**PRE-APPLICATION CONFERENCE  
Juniper Ridge Subdivision  
2024-034 PAC**

Date of Final Report	December 18 ,2024

The applicant proposes a boundary line adjustment between parcels 258944-000 and 258945-000 and subdivision of adjusted parcels into 65 single-family residential lots located in the LDR-7.5 zone. The gross acreage of Parcel 258944-000 following adjustment will be approximately 8.02 acres. The project also proposes frontage improvements to W. F Place, as well as various tracts for residual land areas including critical lands and a tract for a new stormwater facility.

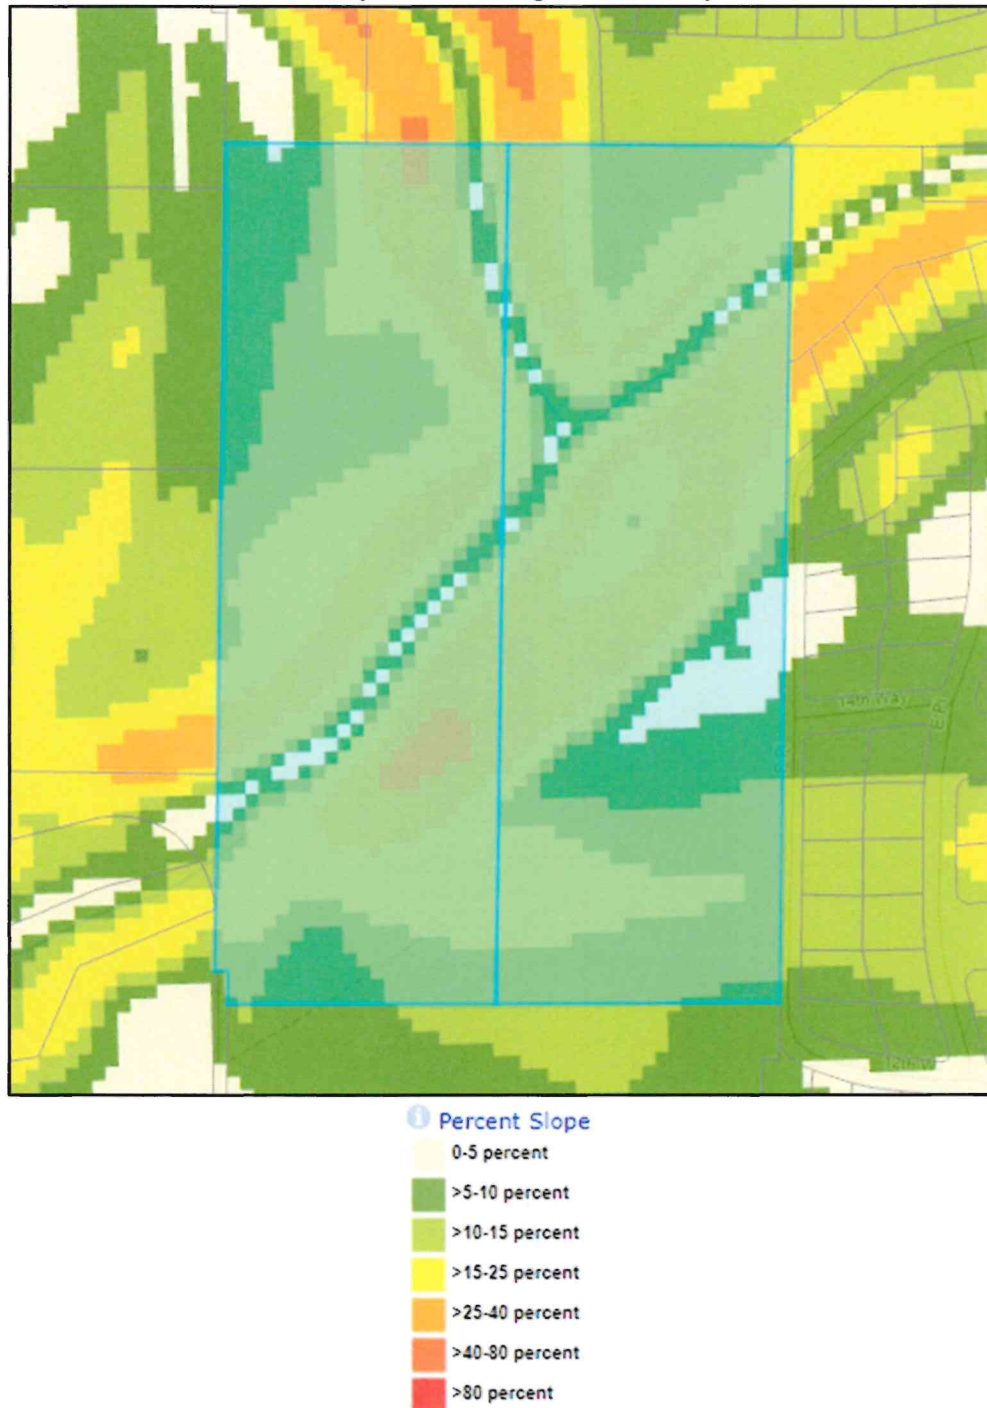
The City’s critical areas ordinance permits buffer reductions of Type N streams of up to 50 percent if the riparian area is currently impacted or has non-native vegetation such as grass or pasture per LCMC 18.300.090(2)(l). The applicant must demonstrate that the proposed buffer reduction will not significantly reduce water quality or habitat functions and must provide a buffer enhancement plan.

**Severe Erosion Hazard Areas**

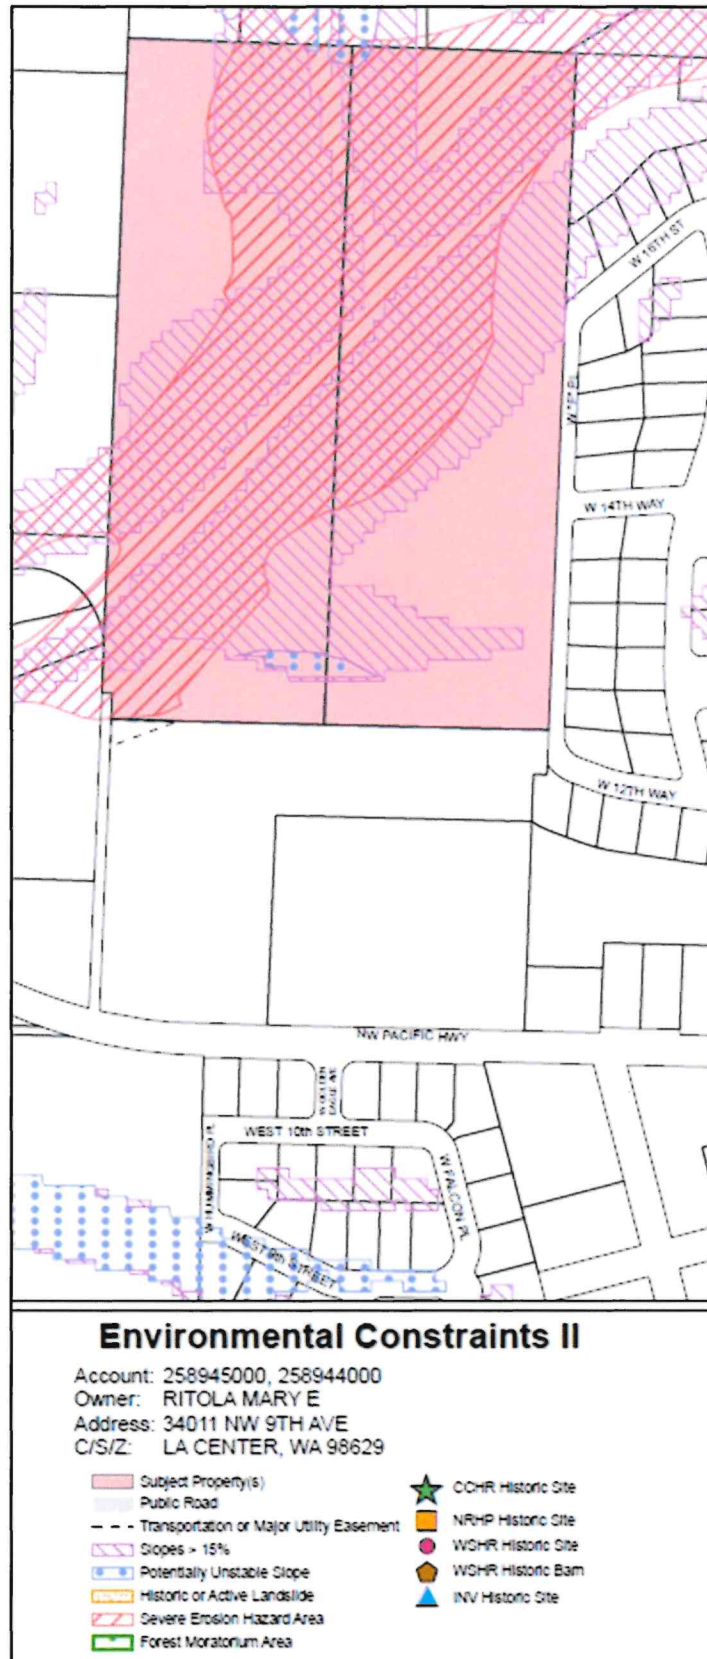
regulated geologically hazardous critical area. Development on lands classified as an erosion hazard areas are prohibited unless the applicant meets the requirements of LCMC 18.300.090(4)(b)(i) and LCMC 18.300.090(4)(c & e). This includes erosion hazard area buffers as recommended in an approved geotechnical report. The applicant must provide an erosion control plan that meets the requirements of LCMC 18.300.090(4)(e)(ii).

These areas are a regulated geologically hazardous critical area. Development on lands classified as a landslide hazard area are prohibited unless the applicant meets the requirements of LCMC 18.300.090(4)(b)(i) and LCMC 18.300.090(4)(c & d). Landslide hazard areas shall be protected with buffers as required by LCMC 18.300.090(4)(d)(i) and as determined by a qualified professional.

## Map 6: Existing & Conceptual Recreational Trails

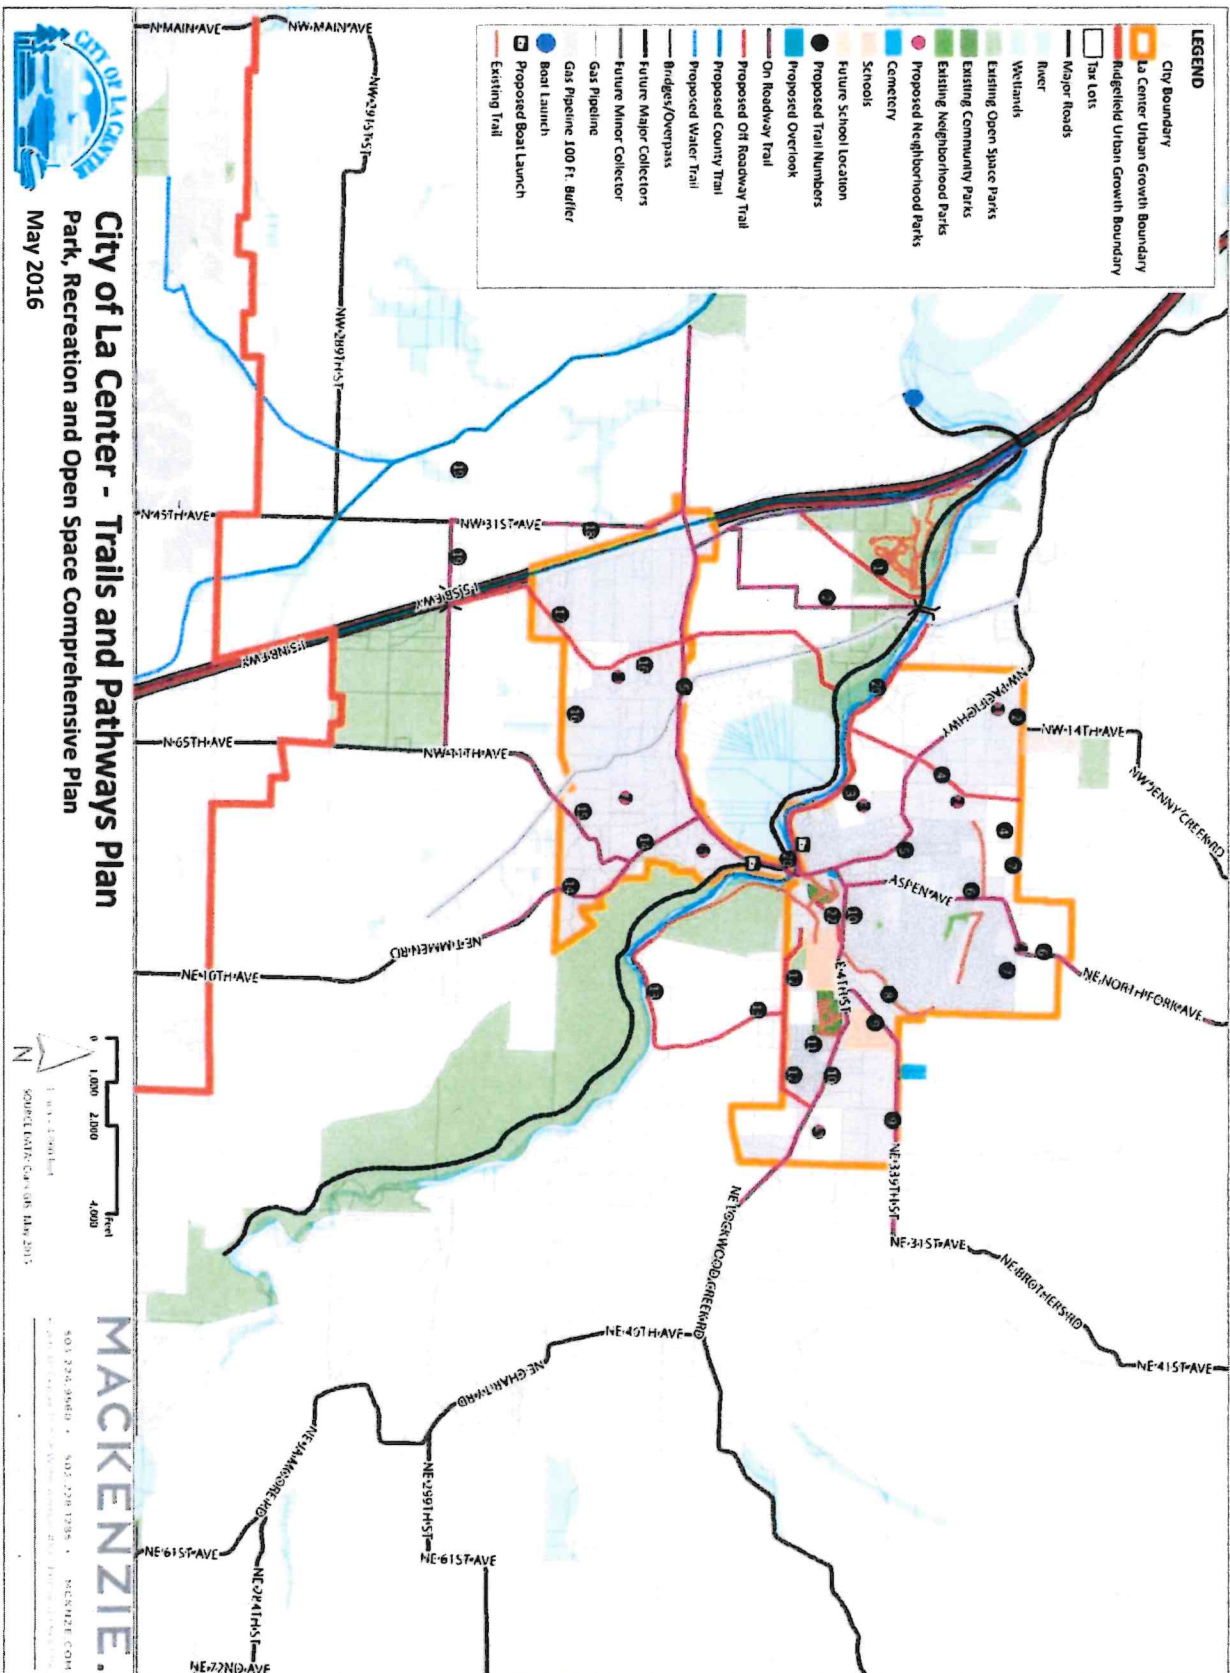
The Park Master Plan is in the process of being updated. In this plan and the existing 2017 park plan, it shows that a future trail extending from Pacific Highway along an unnamed street through the Ritola Property. This trail will eventually connect to the existing trail north of Hannas Farm.

The applicant will need to dedicate right of way and construct for an 8-foot wide trail along this corridor per the rustic trail section T3. The trail will need to connect to Pacific Highway, via 9th Street public right of way. See the park plan map and description

## Excerpts from Hannas Farm sewer plans

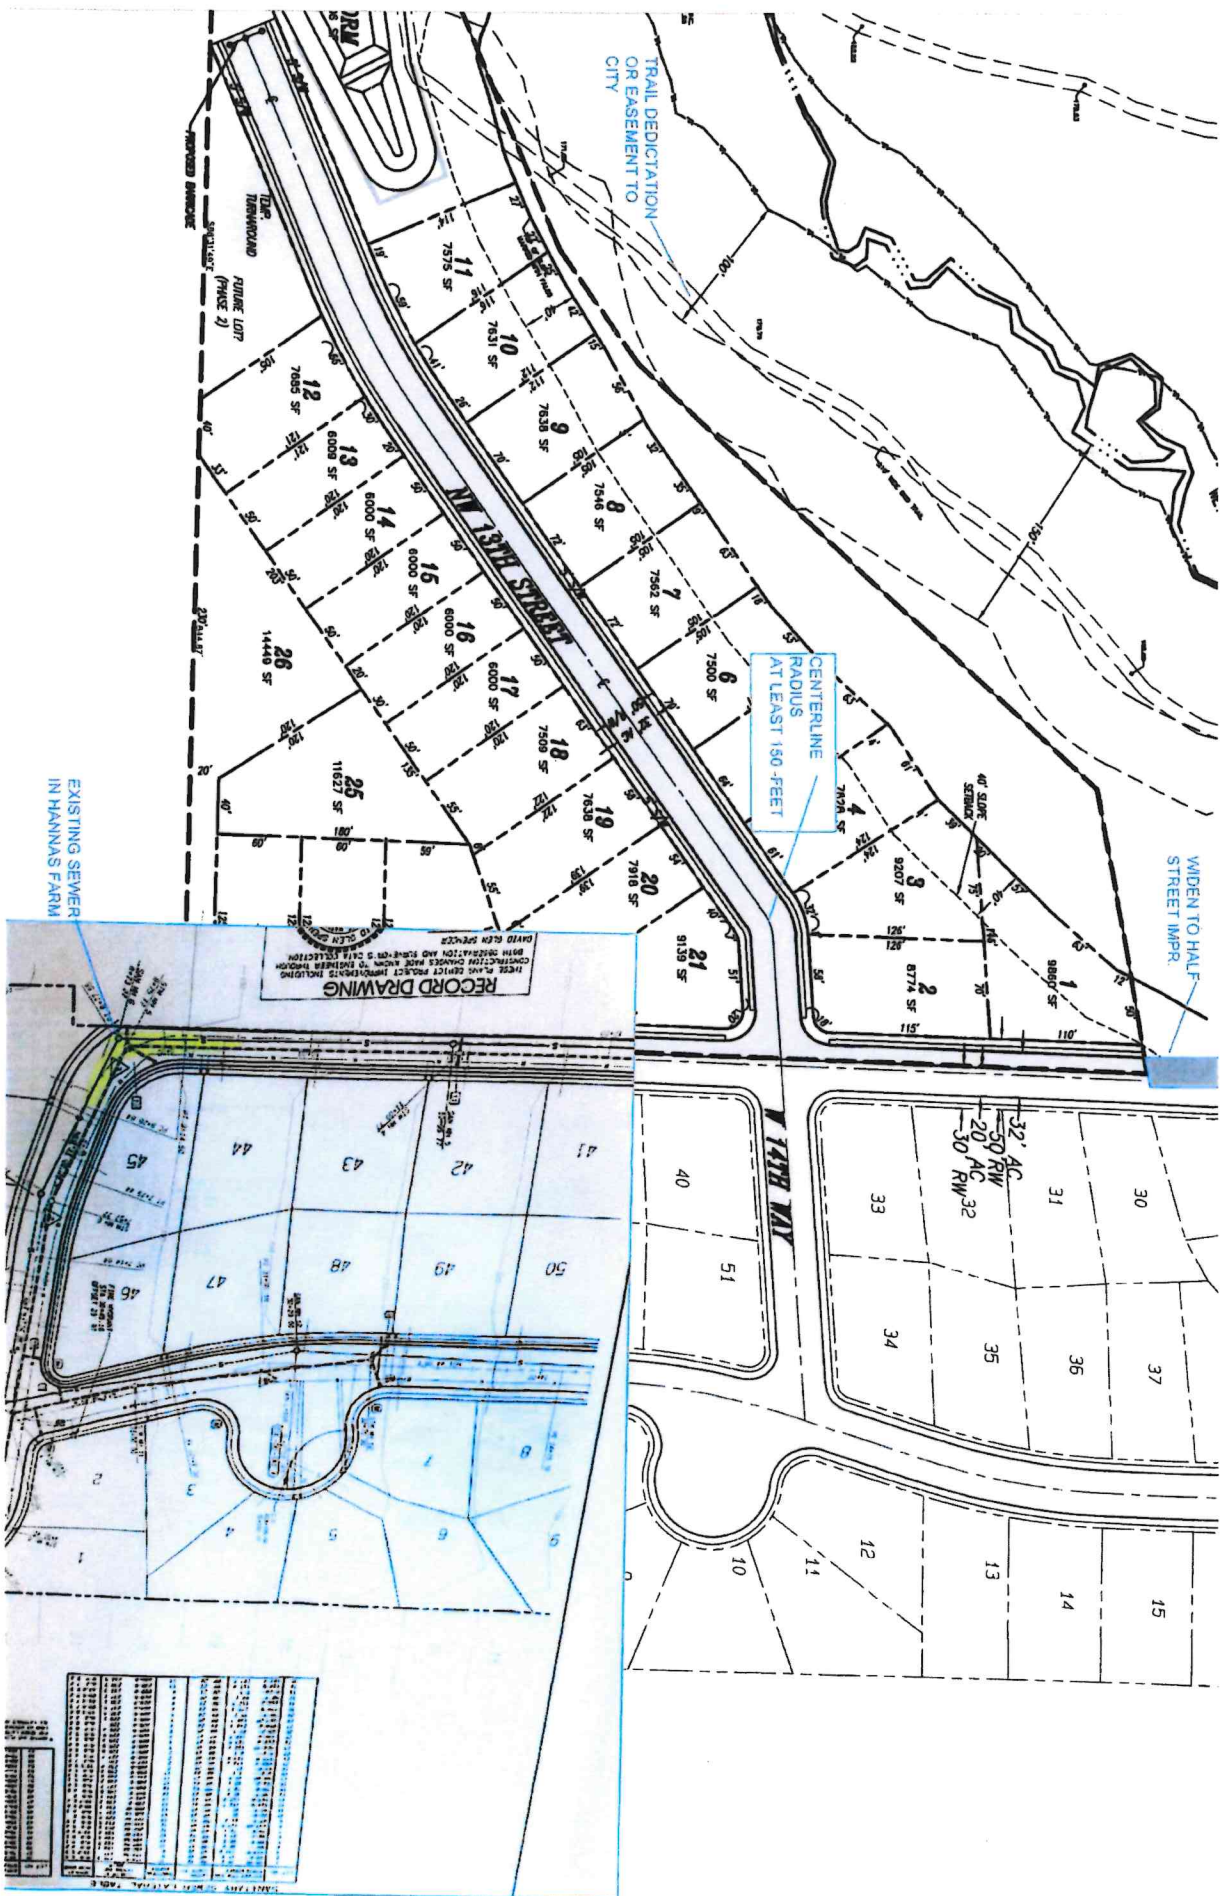
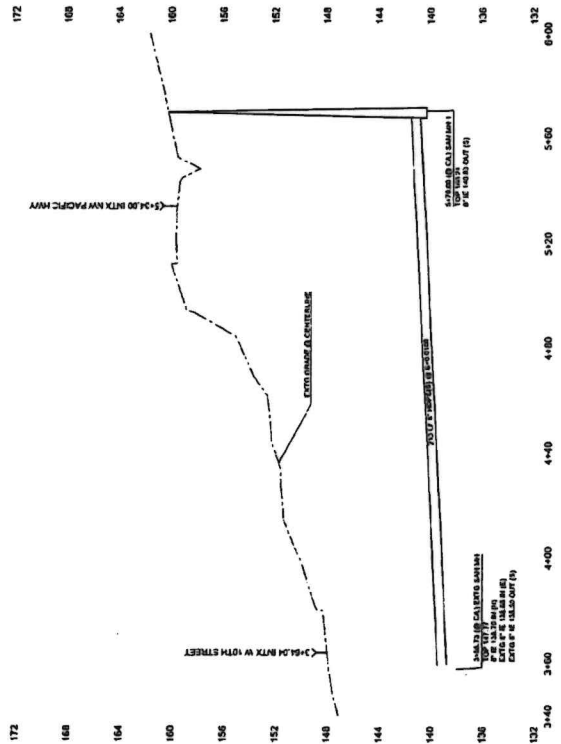
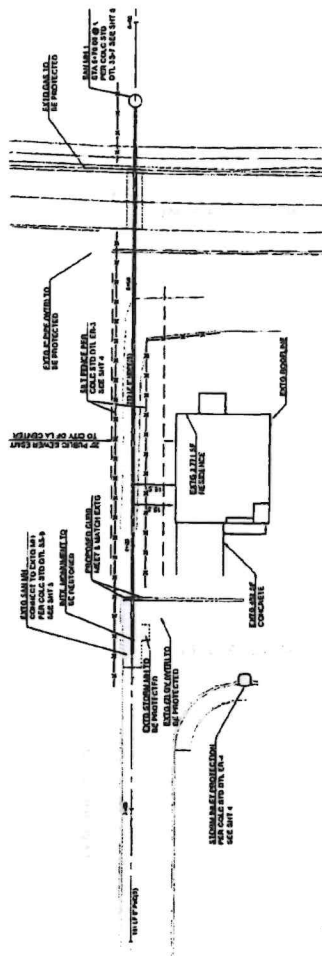
Another alternative is to connect to the gravity storm sewer on private property just north of Pacific Highway, just north of Kays Subdivision. Attached is a plan showing the design that was built. An easement will be needed from the property owner south of Juniper Ridge, to connect to this storm manhole.
